Water Right Conditions Tracking Slip

FILE # # G-17751

PUBLIC INTEREST REVIEW FOR GROUNDWATER APPLICATIONS

TO: Water Rights Section Date January 27, 2014
 FROM: Groundwater Section Mike Zwart
Reviewer's Name
 SUBJECT: Application G- 17751 Supersedes review of _____
Date of Review(s)

D1. Well #: 1 Logid: HARN 51923

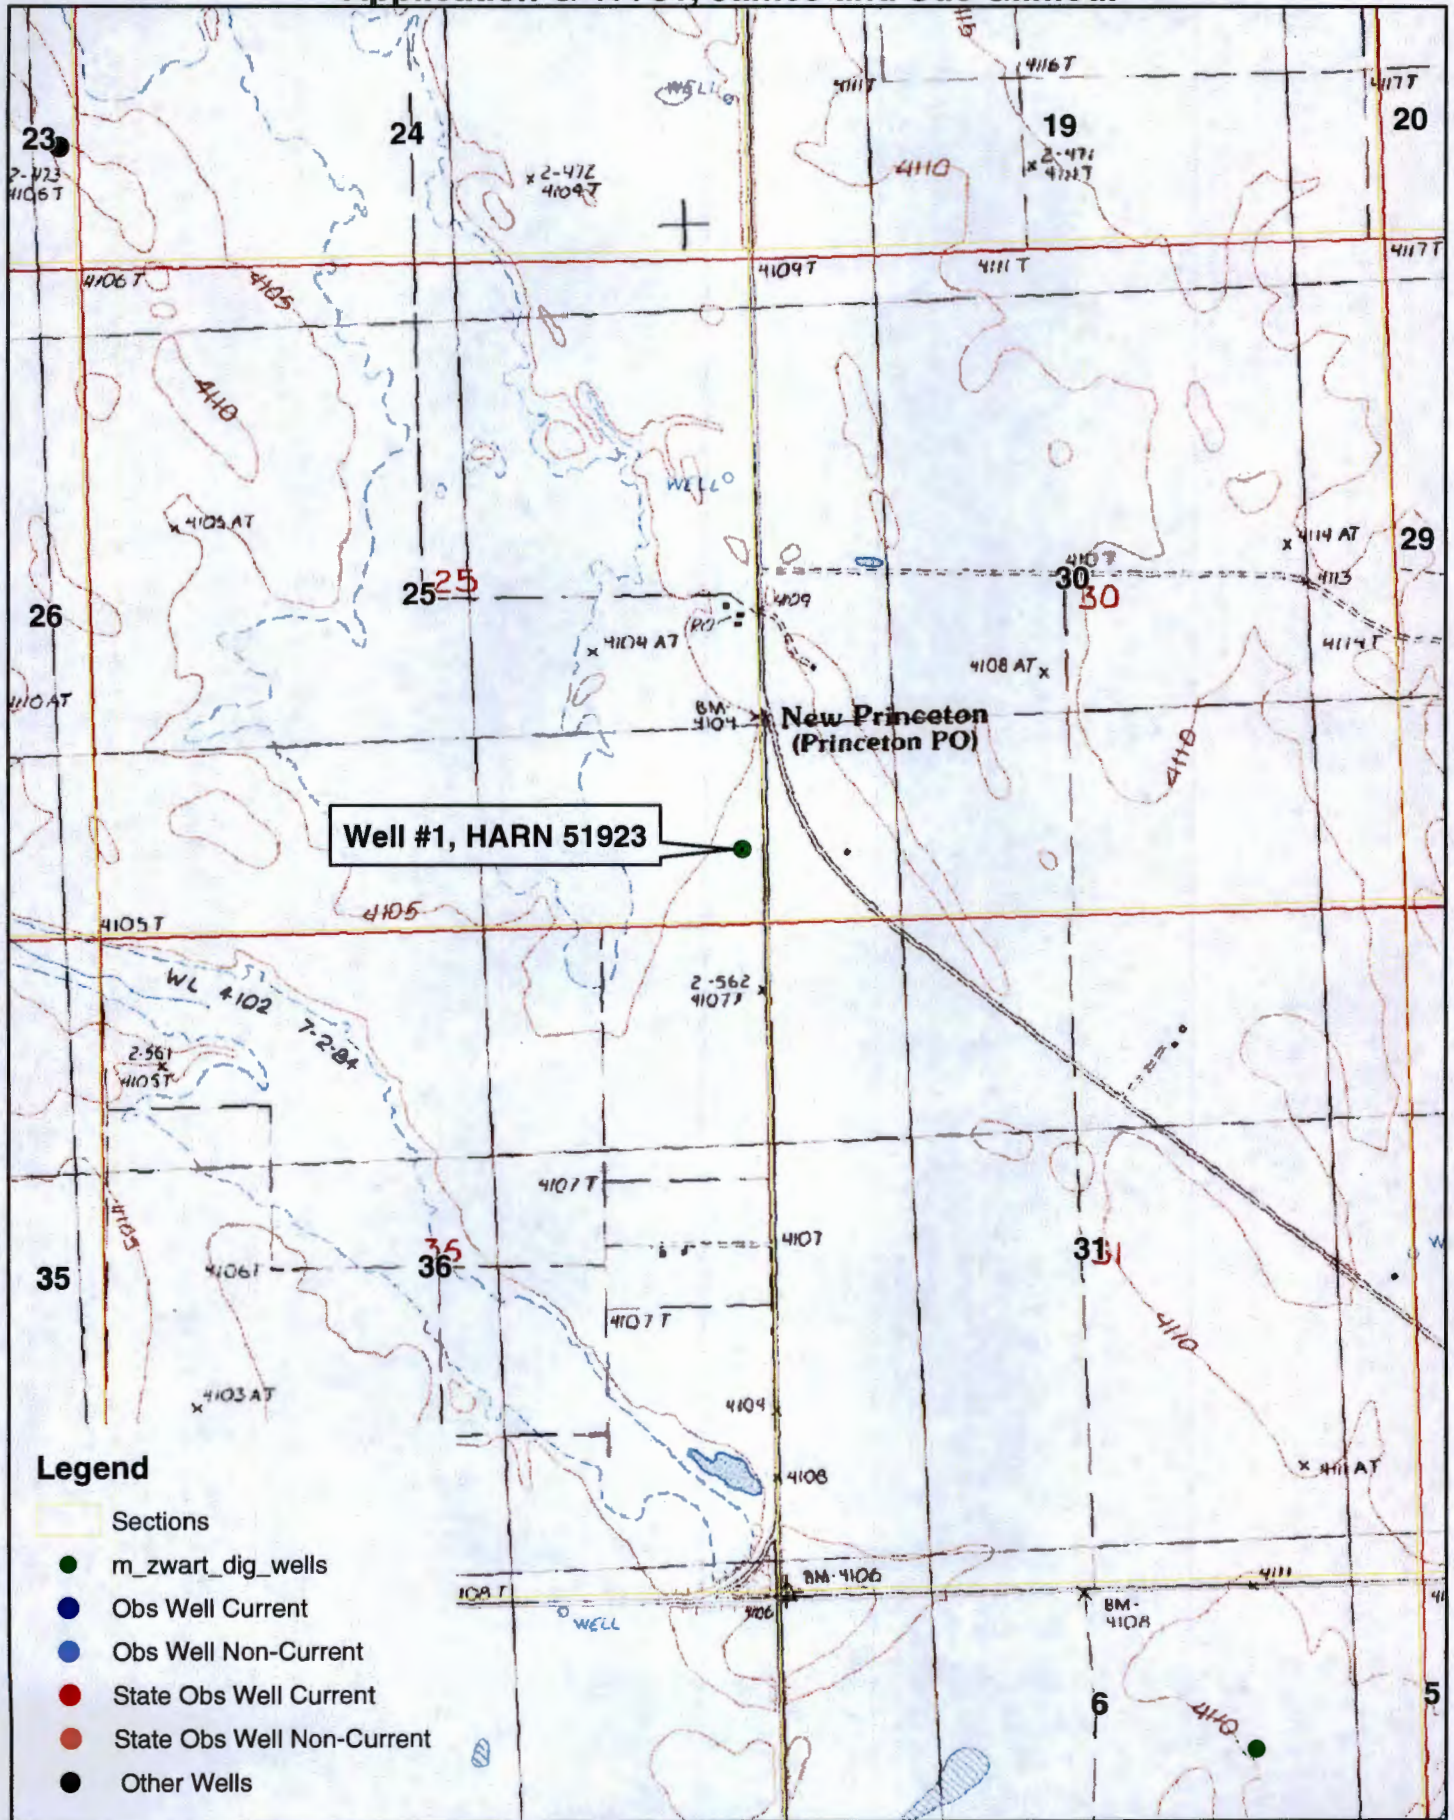
D3. **THE WELL construction deficiency or other comment is described as follows: I have no issues with the construction of this well.**
